PROJECT: Summerlin West Village 22 - Kettle Brook Road - Update #2
(Sunset Run Drive to Kestrel Creek Road)

SUBMITTAL: 4th

CITY OF LAS VEGAS INTER-OFFICE MEMORANDUM		DATE: October 15, 2020
TO: Land Development Services Department of Building & Safety		FROM: Albert Sung, P.E. Flood Control Project Engineer Department of Public Works
SUBJECT:	Drainage Study for: Summerlin West Village 22 - Kettle Bend Road – Update #2 (Sunset Run Drive to Kestrel Creek Road)	
Cross Streets:	Kettle Bend Road & Summerlin Parkway	COPIES TO: VTN Nevada
File Number:	F:\Depot\DSMemos\DS5204F.doc	The Howard Hughes Company, LLC
Parcel Number:	137-23-101-002	Bart Anderson, P.E., DevCo
Zoning Action:	N/A	CCRFC
FEMA Flood Zone	YES _____ NO X	
Proposed Storm Drain	YES X NO _____

4th Submittal: Update #2 to address minor deviation of the connection point of the 8'x8'-RCB into the existing RCB of the Beltway Channel

2020-09-25
SHEET
UT5
45 OF 107 SHEETS
DRAWING NO.
L20-01282
107V8449

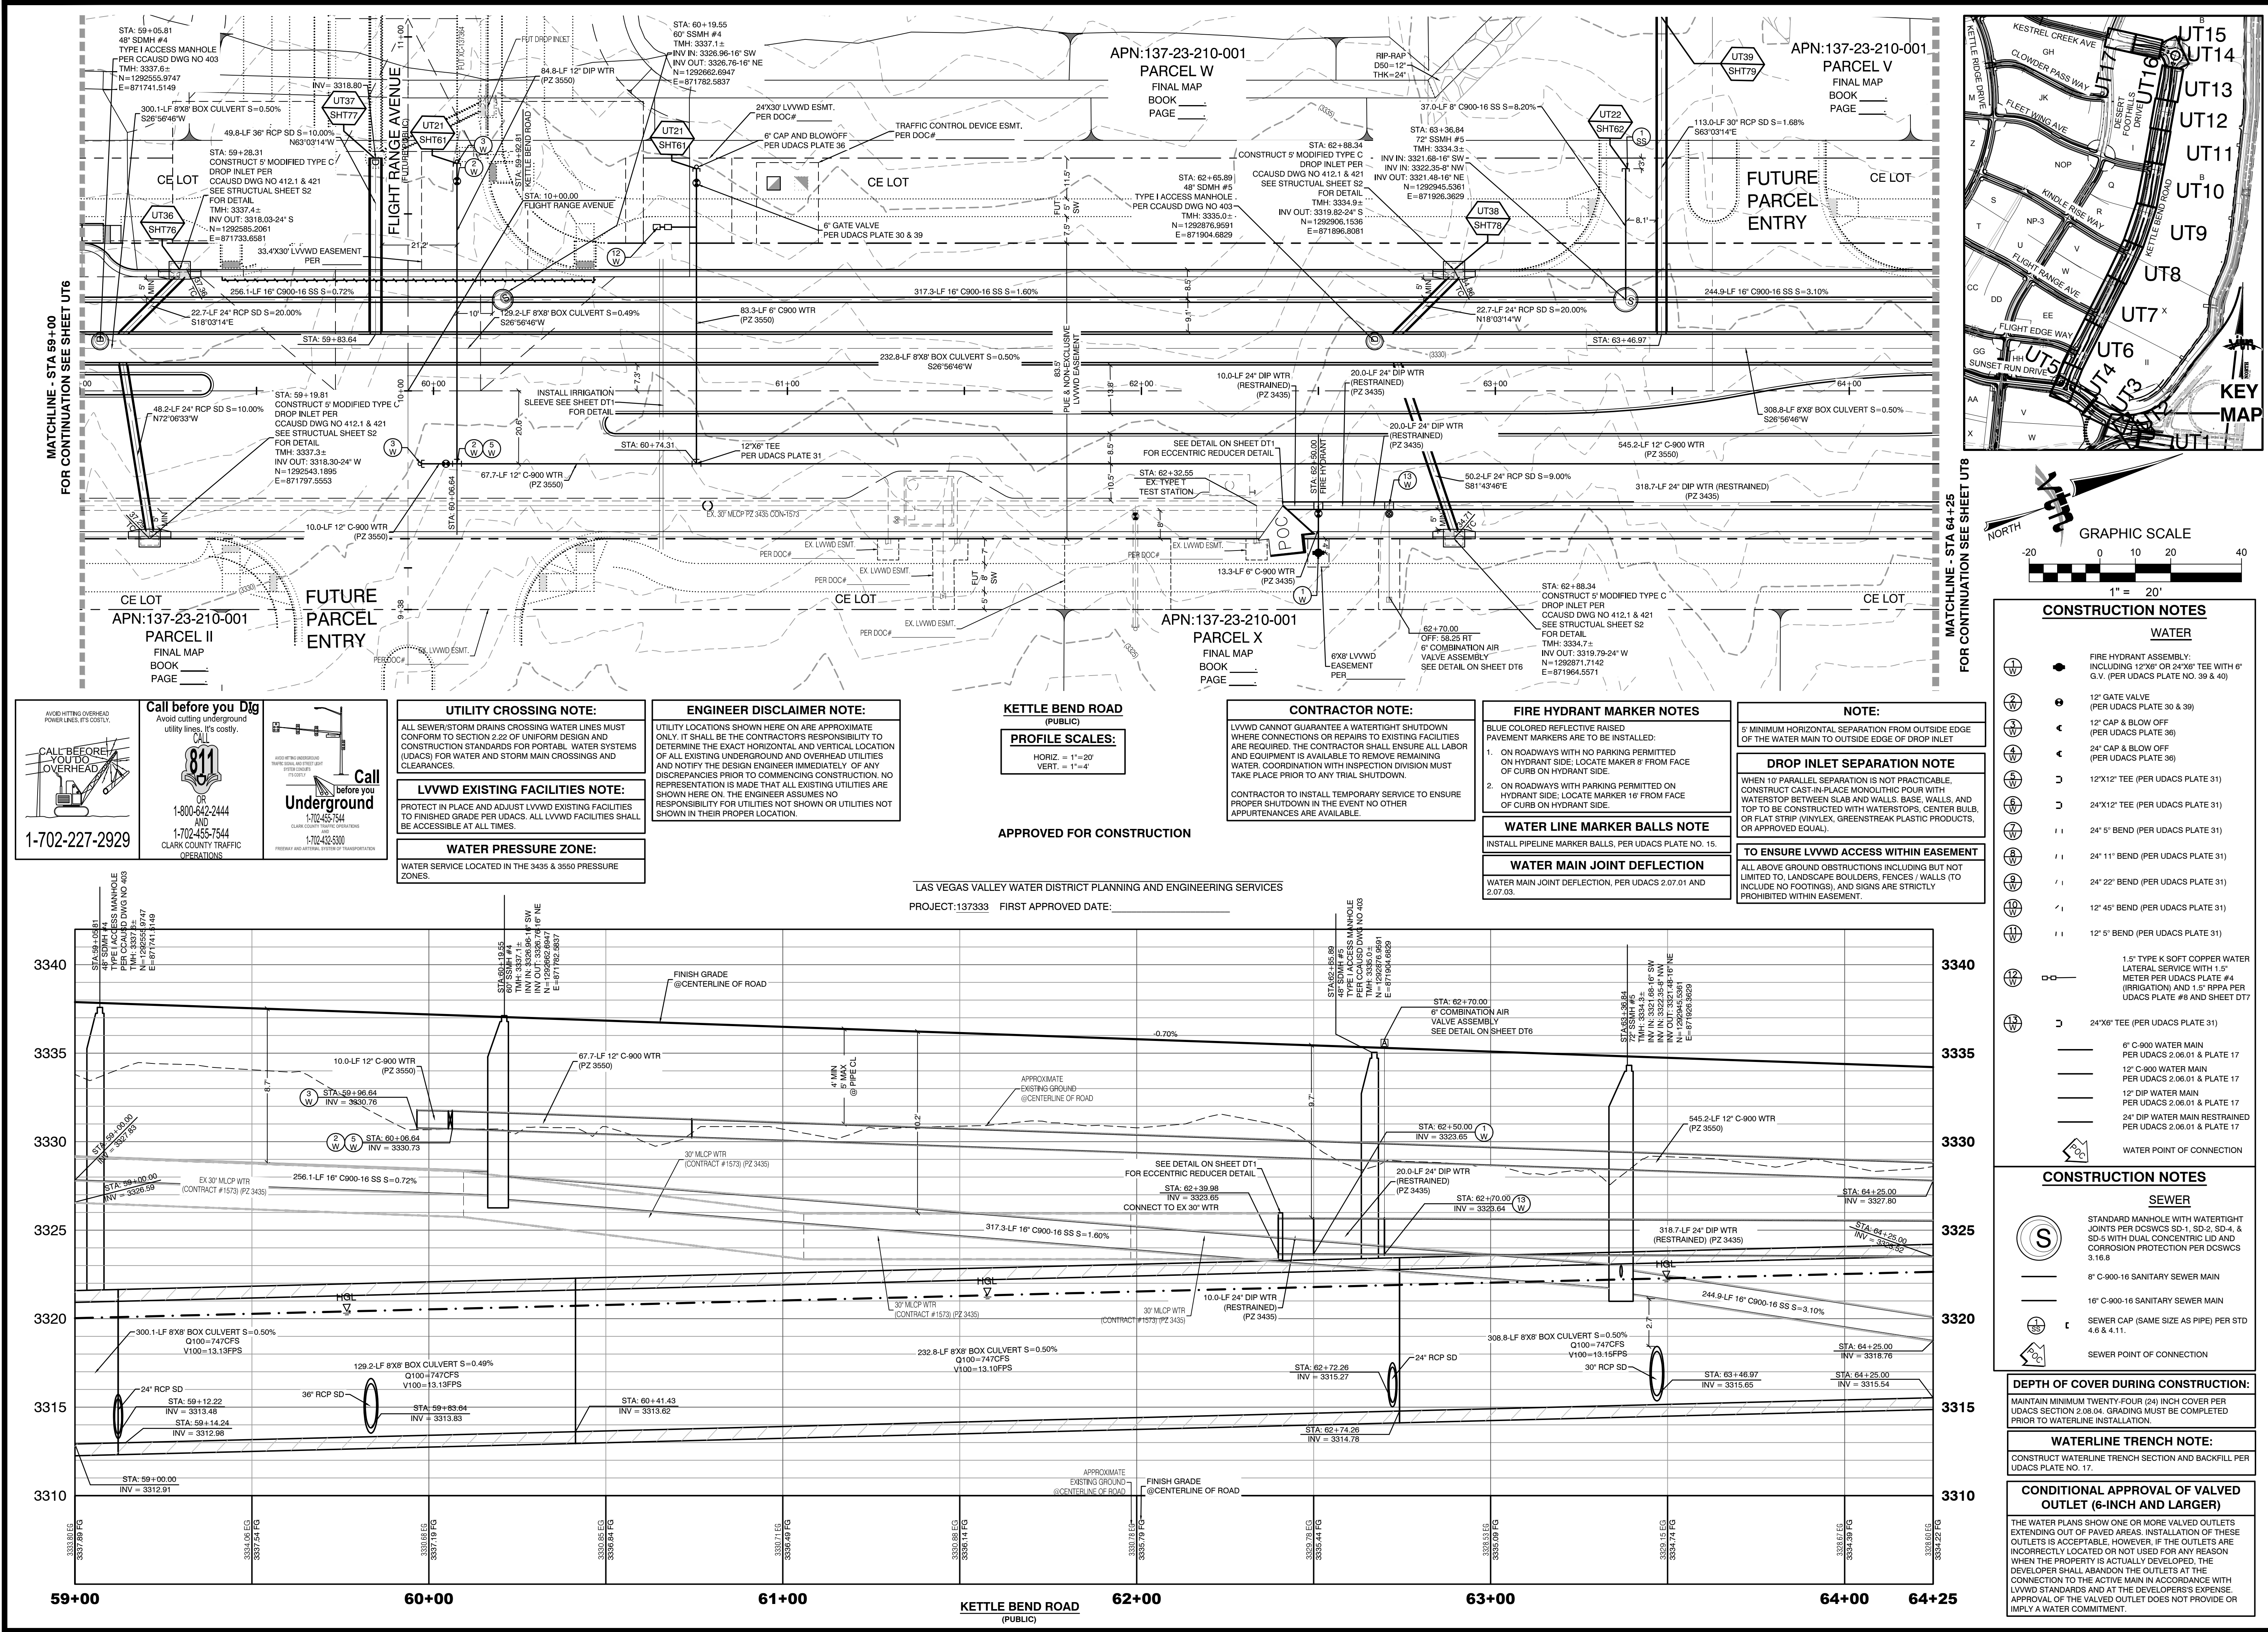
Sheet UT1 to Sheet UT5: *The regional facility 8'x8' RCB in Sunset Run Drive is too close to the northern curb. In case of needing repair and maintenance in the future, the staging area will break into the curb area which is costly and problematic. Relocate the RCB to the center of the street as far as possible.*

The response was to maintain the original proposed location for the proposed regional facility 8'x8' RCB in *Sunset Run Drive*.

In the final map, dedicate the amenity zone behind the northern curb of *Sunset Run Drive* and east of *Kettle Bend Road* as a Public Drainage Easement to be Privately Maintained by the *Summerlin Master HOA*.
